Rezoning Transportation Analysis

Petition Number: 2021-092

Date	Description
06-01-2021	First Review (KP)

Sheet RZ-1.1 – Typical Sections

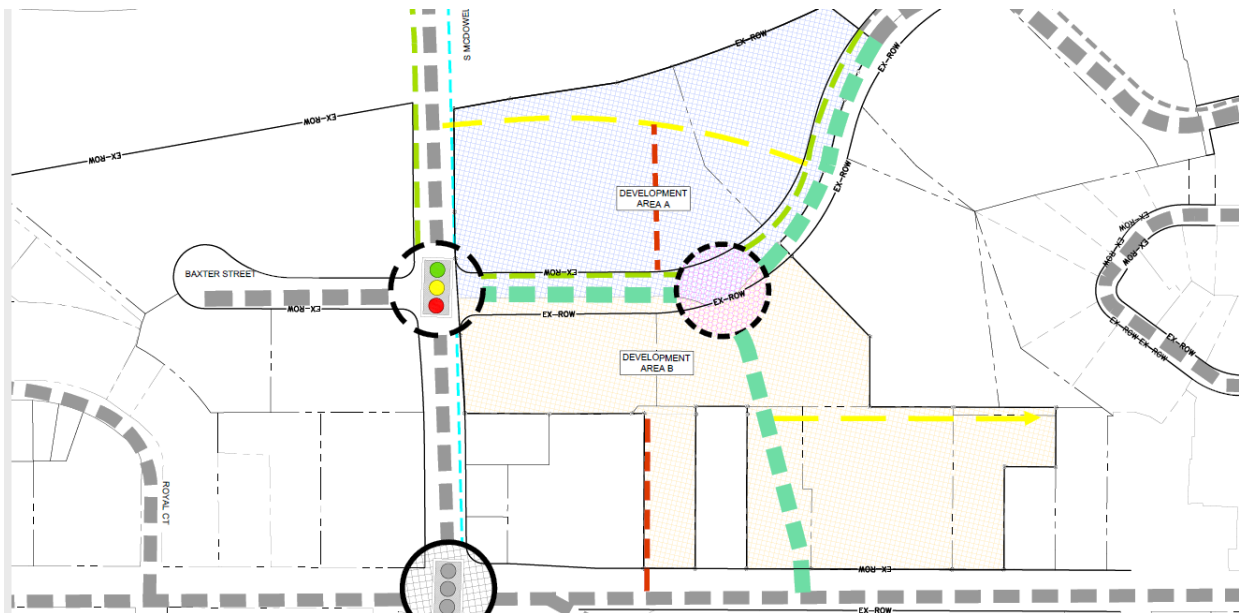
1. **Curb line:** The proposed zoning district has a setback measured from back of the existing or proposed future curb line. Revise Sheet RZ-1.1 by adding the curb line dimensions to the cross sections provided. Please note: The following curb line dimensions proposed are conceptual and may be altered as coordination with CDOT throughout the rezoning process ensues.

- a. **Morehead Street:** The location of curb and gutter will be moved and located 38-feet from the existing centerline to the back-of-curb.
 - b. **McDowell Street:** The future location of curb and gutter is in the existing location.

- c. **Baxter Street (Section C-C)** – The location of curb and gutter will be moved and located to 21.5-feet from the existing centerline to each back-of-curb.

- d. **Baxter Street (Section D-D)** – The location of curb and gutter will be moved and located to 19-feet from the existing centerline to each back-of-curb.

- e. **Baxter Street Extension (Section E-E)** – The location of curb and gutter will be moved and located to 21.5-feet from the existing centerline to each back-of-curb.

- f. **Proposed Public Street (Section F-F)** - The location of curb and gutter will be located 18.5-feet from the proposed centerline to each back-of-curb.

3. **Right-of-way and Other Infrastructure Dimensions:** Revise Rezoning Sheet RZ-1.1 to include detailed dimensions for each infrastructure item, and the total right-of-way for the cross sections shown. Refer to the USDG Cross sections and on-street parking details, located within the Charlotte Land Development Standards Manual, to determine the appropriate widths associated with each infrastructure item and the cross sections' total widths. Revise the site plan sheets by clearly labeling each public and private street section as well as each access point. Labeling each street section and access point will allow for thorough comments throughout the rezoning and permitting process. CDOT prefers the separated cycle track and sidewalk for McDowell Street (cross-sections A-A and B-B). Please note: The following right-of-way dimensions proposed are conceptual and may be altered as coordination with CDOT throughout the rezoning process ensues.

- a. **Morehead Street:** 56-feet of right-of-way dedication measured from the existing road centerline.
 - b. **McDowell Street:** 110-feet of total right-of-way dedication, 55-feet measured from the existing road centerline to each right-of-way line.

- c. **Baxter Street (Section C-C)** – 93-feet of total right-of-way dedication, 46.5-feet measured from the existing road centerline to each right-of-way line.

- d. **Baxter Street (Section D-D)** – 86-feet of total right-of-way dedication, 43-feet measured from the existing road centerline to each right-of-way line.

- e. **Baxter Street Extension (Section E-E)** – 93-feet of total right-of-way dedication, 46.5-feet measured from the existing road centerline to each right-of-way line.

- f. **Proposed Public Street (Section F-F)** - 73-feet of total right-of-way dedication, 36.5-feet measured from the existing road centerline to each right-of-way line.

Sheet RZ-1.3 – Ped and Bike Connectivity

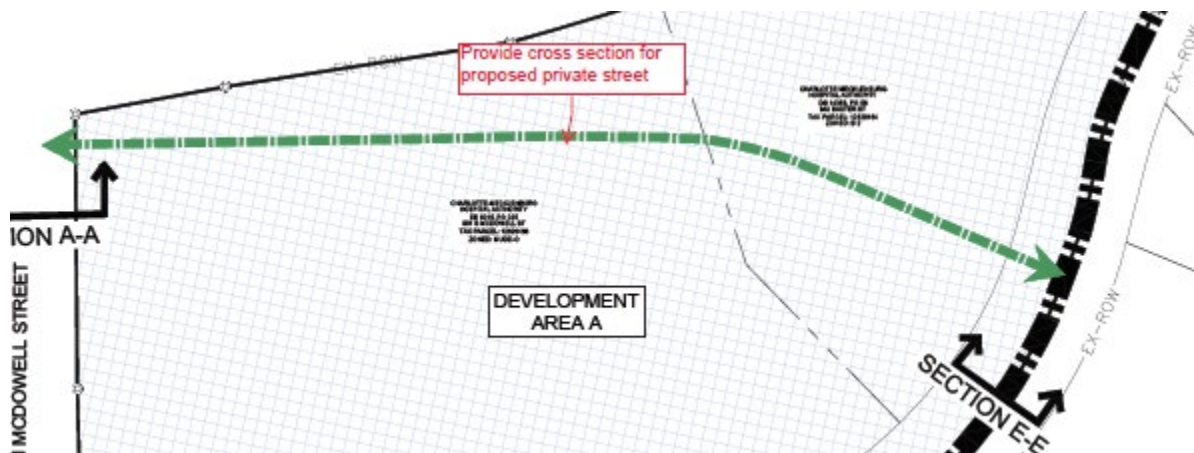
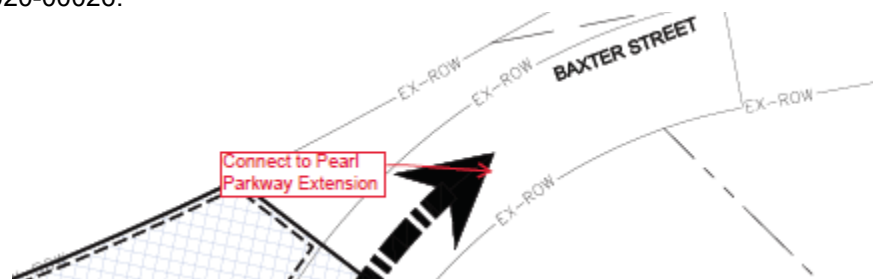
4. Revise the Rezoning Sheet RZ-1.0 and RZ-1.1 by establishing a cross section associated with the proposed private street connecting McDowell Street to Baxter Street Extension. Include the cross section on Rezoning Sheet RZ-1.1.
